A12 Chelmsford to A120 widening scheme

TR010060

DEVELOPMENT CONSENT ORDER CHANGE APPLICATION SURFACE WATER DRAINAGE STRATEGY ADDENDUM

Surface Water Drainage Strategy Addendum

Plate 5.2 Revised highway drainage design proposals in the vicinity of the B1023 Road compared with the design submitted in August 2022 (Cluster Area 2)

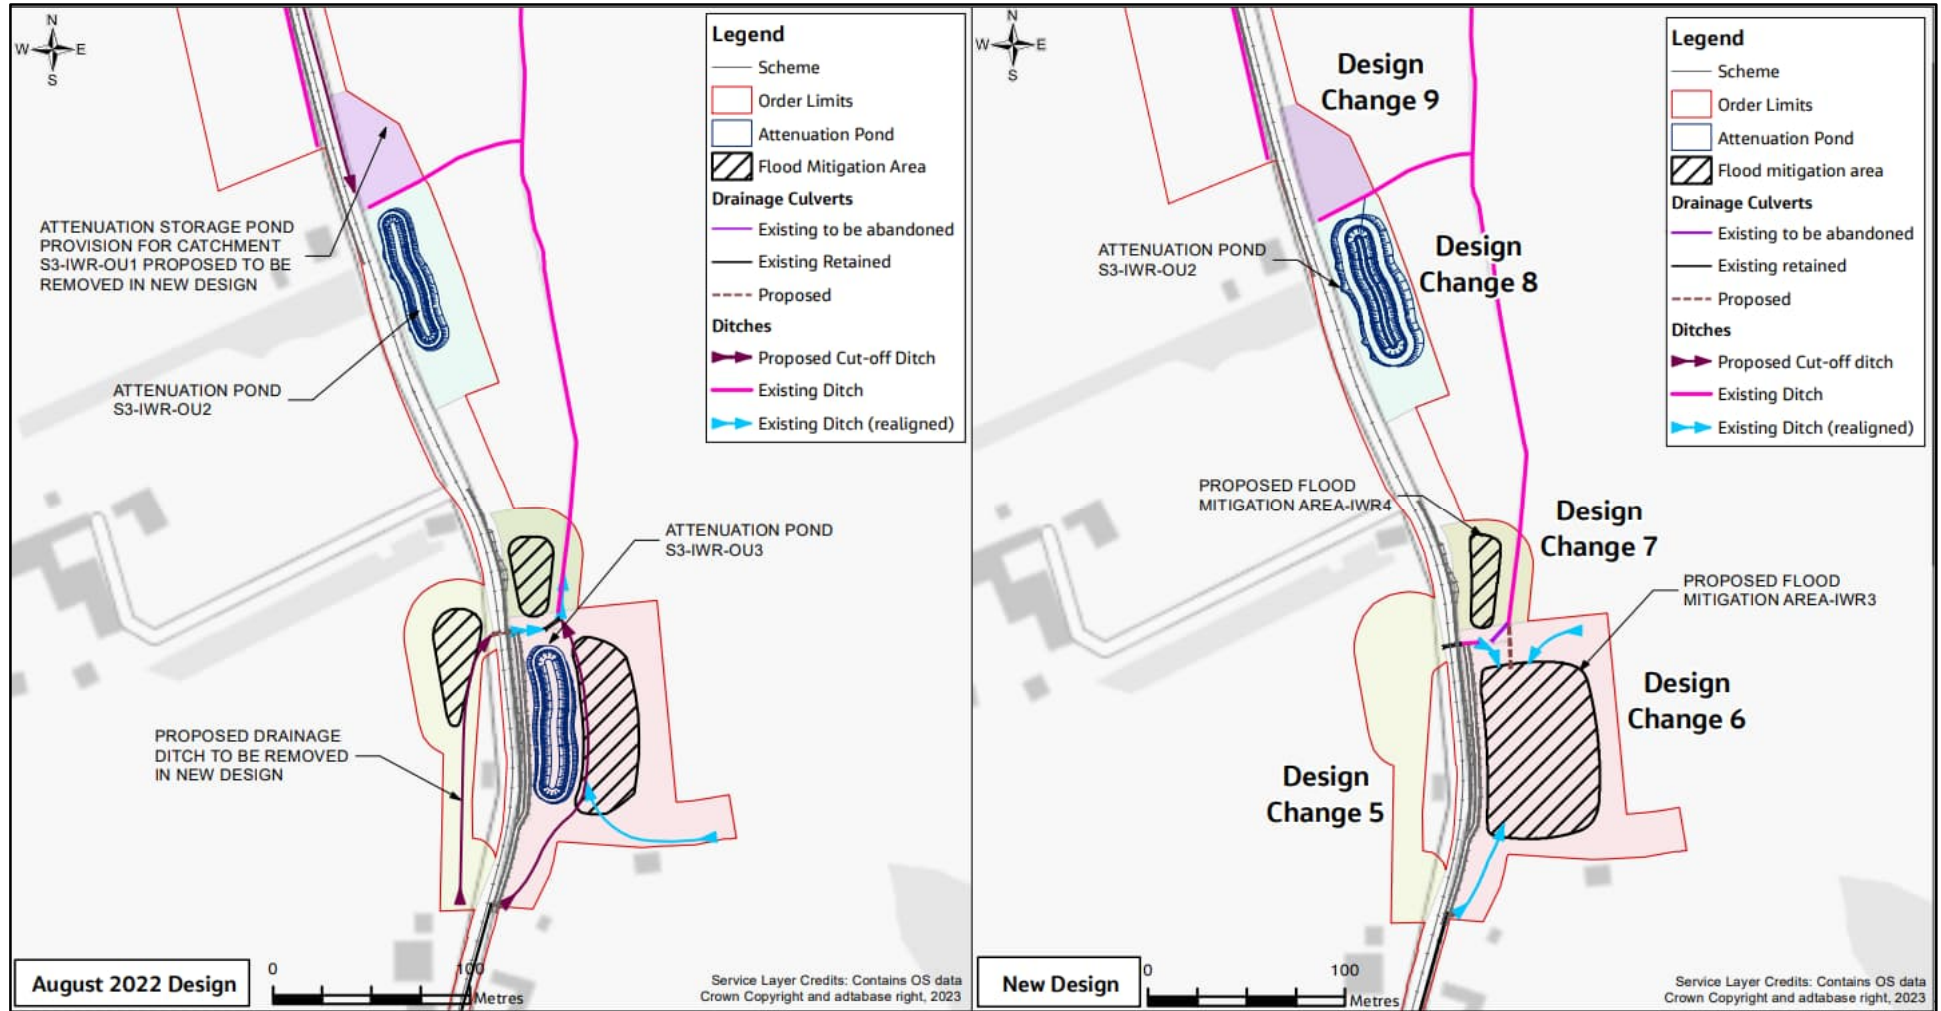
Landtake area reference from Plate 5.2	New highway drainage design solution
Design Change 5	Previously proposed drainage ditch removal – Located adjacent to the B1023 Road, at Inworth, this proposed drainage ditch was considered for the design submitted at DCO application and is no longer required. This previously proposed drainage ditch can be removed as the additional drainage survey identified existing field drains/ditches that will be retained.
Design Change 6	Proposed S3-IWR-OU3 catchment attenuation pond removal - A new design solution has been developed to enable the most efficient use of the available land take for the proposed scheme while integrating the design solutions for the proposed scheme required for both the proposed highway drainage attenuation storage (proposed S3-IWR-OU3 catchment attenuation pond) and the watercourse flood risk mitigation storage (proposed flood mitigation area – IWR3). This design solution comprises the removal of the previously proposed S3-IWR-OU3 catchment attenuation pond and diverting the highway drainage catchment to the downstream proposed S3-IWR-OU2 catchment attenuation pond. The design development process that has enabled the removal of this previously proposed attenuation pond is discussed in paragraph 5.2.8.

Design Change 7	Watercourse flood mitigation storage area (proposed flood mitigation area – IWR4) retained - Refer to FRA Addendum [TR010060/EXAM/10.16] for further details on the design requirements associated with this design change.
Design Change 8	Proposed S3-IWR-OU2 catchment attenuation pond retention and volume increase - This proposed highway drainage attenuation pond is retained. However, an increase in the proposed attenuation storage volume and associated footprint is required (i.e. in comparison to the DCO application design) as a result of the additional highway drainage catchment draining to this attenuation storage pond which was previously draining to the proposed S3-IWR-OU3 catchment attenuation pond (i.e. Design Change 6). The design development process for the proposed S3-IWR-OU2 catchment attenuation pond volume increase is discussed in paragraph 5.2.9.
Design Change 9	Potential location for highway drainage attenuation storage pond provision removal - This location was previously considered as a potential location for highway drainage attenuation storage provision for the proposed S3-IWR-OU1 catchment which now drains through the proposed S3-OU8B+OU8D catchment attenuation storage ponds. The design development process that has enabled this design change is discussed in paragraph 6.2.

5.2.8 The highway drainage design for the proposed S3-IWR-OU3 catchment (including the proposed S3-IWR-OU3 attenuation pond) is affected by the proposed flood mitigation measure requirements associated with the nearby watercourses. More detailed topographic surveys have been undertaken as part of the post-DCO surveys which have been used for the hydraulic modelling of the nearby watercourses. As a result it has been found that the most practicable location for the proposed realigned watercourse and associated proposed watercourse flood mitigation storage area is adjacent to the B1023 Road which coincides with the previously proposed S3-IWR-OU3 catchment attenuation pond. Therefore, the proposed S3-IWR-OU3 catchment highway drainage is proposed to be diverted to the adjacent proposed S3-IWR-OU2 catchment highway drainage system which was found to be feasible. This has enabled the removal of previously proposed S3-IWR-OU3 catchment attenuation pond.

5.2.9 Further to the “Design Change 8” description in Table 5.1, hydraulic modelling has been undertaken for the combined highway drainage catchments (i.e. the proposed S3-IWR-OU2, S3-IWR-OU3 and S3-IWR-OU4 catchments) diverted to the proposed S3-IWR-OU2 attenuation pond. The hydraulic modelling results confirm an increase in the attenuation storage volume requirements for the proposed S3-IWR-OU2 catchment attenuation pond and its associated footprint. However, the increased attenuation pond footprint can be accommodated within the Order Limits submitted at DCO application. The proposed S3-IWR-OU2 catchment attenuation pond earthworks has been adjusted locally to minimise the impact on the nearby existing foul sewer located in this area.

Plate 6.1 Revised highway drainage design proposals for the segregated left turn removal at the Junction 24/B1023 Road at Inworth compared with the design submitted in August 2022

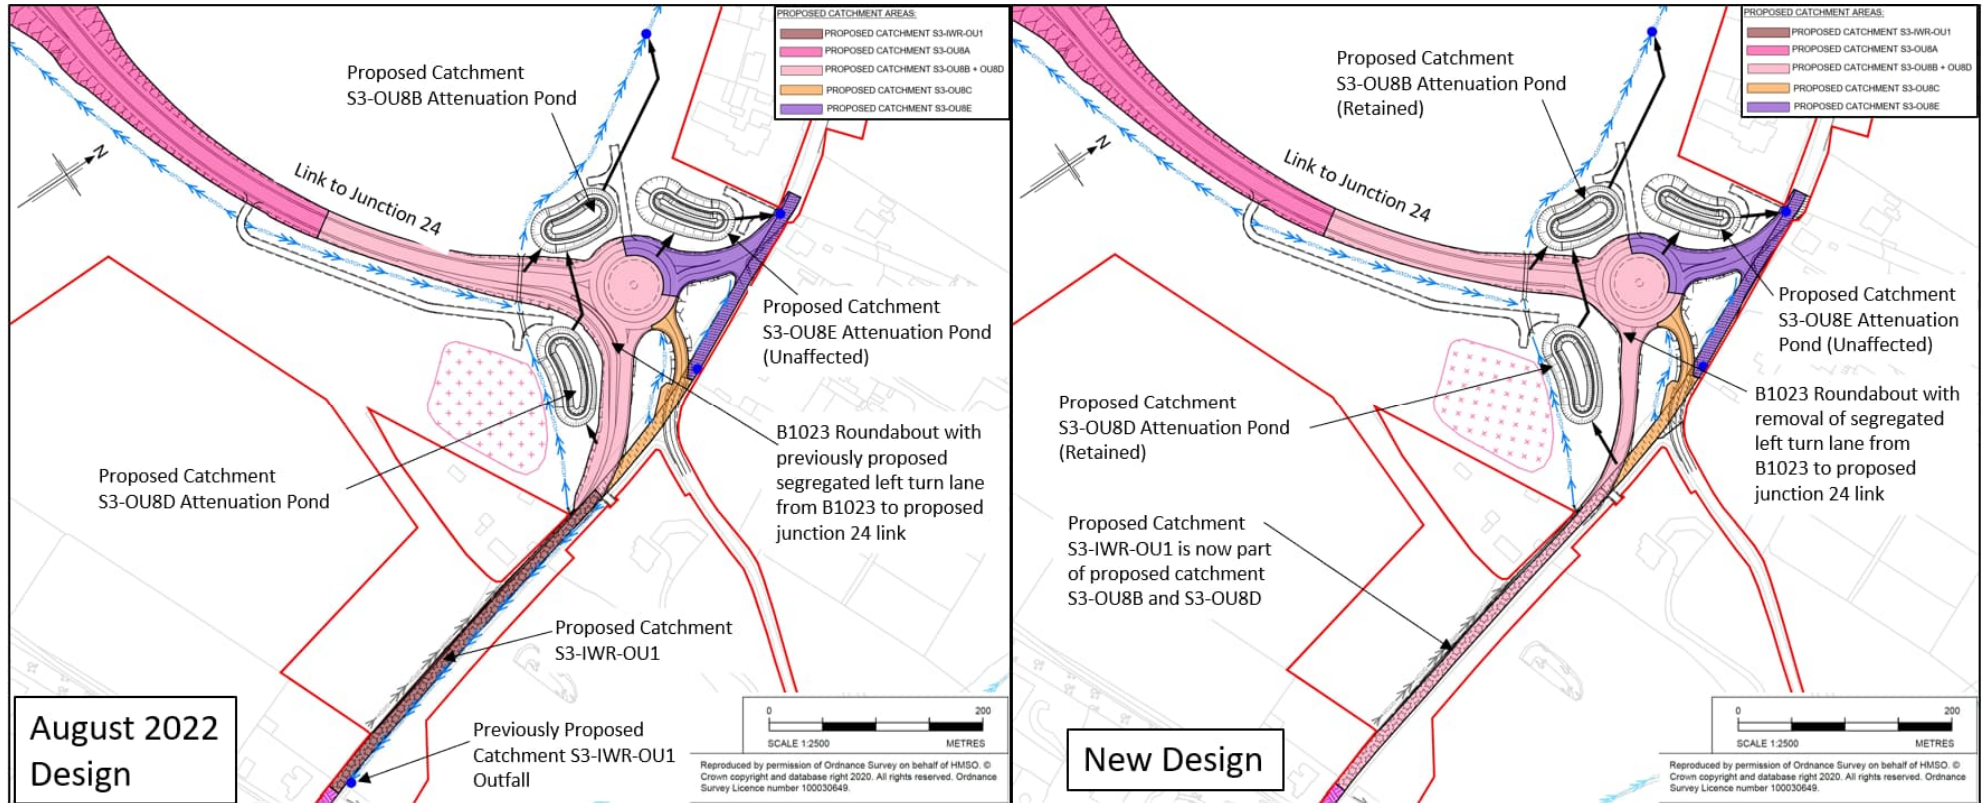
6.1.1 The proposed highway design change involves the removal of a previously proposed segregated left turn lane (SLTL) from the proposed B1023 roundabout general arrangement. Refer to Section 2.6 of the ES Addendum [TR010060/EXAM/10.12] for further details on the proposed design change, including the reasons as to why this change is being proposed. Plate 6.1 presents a schematic comparison of the proposed highway design change for the B1023 roundabout to the design submitted at DCO.

6.2.1 The removal of the SLTL at the proposed B1023 roundabout, will result in a small reduction in paved area associated with the proposed S3-OU8B + OU8D catchments. The reduction in the paved area catchment associated with the SLTL will be adjusted against the existing S3-IWR-OU1 catchment, which is now proposed to be drained through the proposed S3-OU8B + OU8D catchment (i.e. Design Change 9 described in Table 5.2 provided for the B1023 Kelvedon Road design).

6.2.2 The DCO design submitted for the proposed S3-IWR-OU1 catchment included the proposed highway drainage would discharge to an existing ditch located adjacent to the B1023 Road. Spatial provision (i.e. Design change 9 as described previously in Table 5.2) was made accordingly as part of the DCO highway drainage design to attenuate the surface water runoff from the proposed S3-IWR-OU1 catchment. However, the post-DCO drainage surveys revealed that the existing highway drainage for the S3-IWR-OU1 catchment extends further north along Inworth Road and eventually drains into an existing highway drainage system that discharges to Domsey Brook. As a result, the previously planned attenuation pond provision and outfall arrangement could not be retained for the proposed S3-IWR-OU1 catchment. Therefore, an updated highway drainage design solution is required for the attenuation of surface water runoff from the proposed S3-IWR-OU1 catchment.

6.2.3 The previously described reduction in the proposed S3-OU8B + S3-OU8D catchment area (i.e. paragraph 6.2.1), which is located adjacent to the proposed S3-IWR-OU1 catchment, provided an opportunity to assess the feasibility of combining these adjacent catchments. The updated combined proposed S3-OU8B + S3-OU8D catchment results in a small increase to the paved area compared the highway drainage design submitted at DCO application. The hydraulic modelling of the updated combined proposed S3-OU8B + OU8D catchment has been undertaken which has confirmed a

small increase in the associated attenuation storage volumes for the proposed S3-OU8B + S3-OU8D catchments. However, this small increase in the attenuation storage volume will not have an impact on the proposed attenuation storage ponds footprint reported for the highway drainage design at DCO application. This is because the proposed S3-OU8B + S3-OU8D catchment attenuation storage ponds were found to have adequate attenuation storage capacity following the optimisation of the attenuation pond base invert level / side slopes geometry relative to the surrounding natural terrain (i.e. steep terrain and / or high ground). Therefore, there is no impact to the proposed S3-OU8B + S3-OU8D attenuation pond design to that submitted at DCO (with the exception of the previously proposed S3-IWR-OU1 catchment attenuation pond provision removal).
